10/687,582

C14-163313M/YAH (NGB.039Cont)

AMENDMENTS TO THE DRAWINGS

REMARKS

FIG. 1

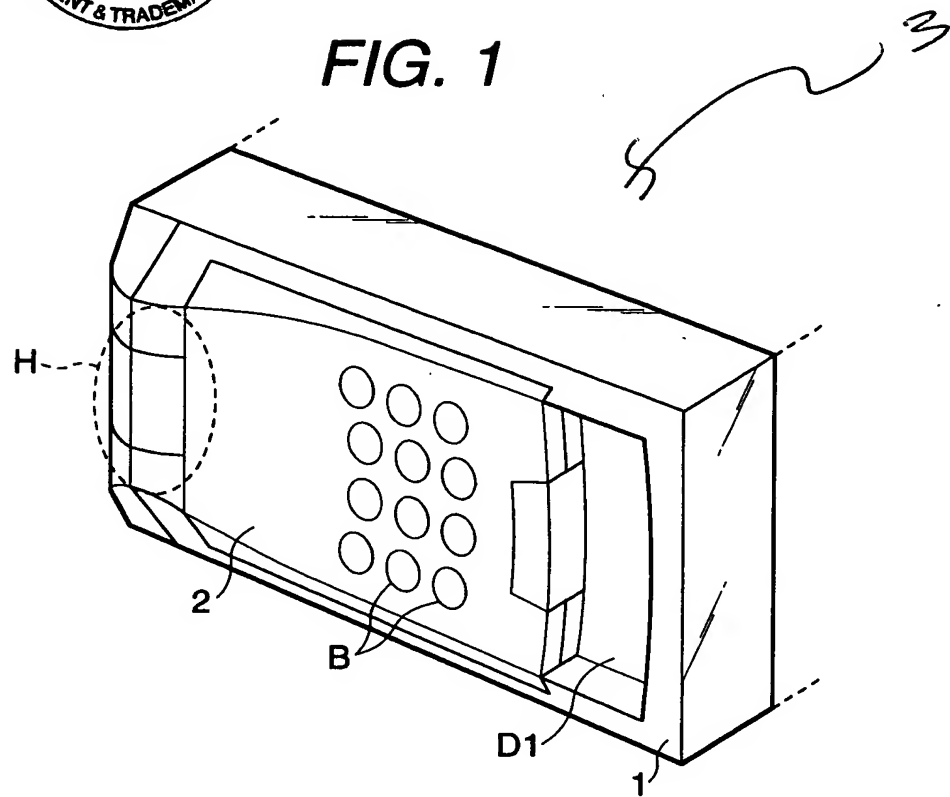
The attached drawing sheet includes a change to Figure 1 to add a label "3" for the dashboard of the automobile upon which the present invention is mounted. This sheet replaces the original sheet which contains Figure 1.

The Examiner objected to the drawings for failing to show the feature that the present invention is intended to be mounted on a surface of an automobile. Applicants believe that the above drawing and specification changes address this concern and respectfully request that the Examiner reconsider and withdraw this objection.
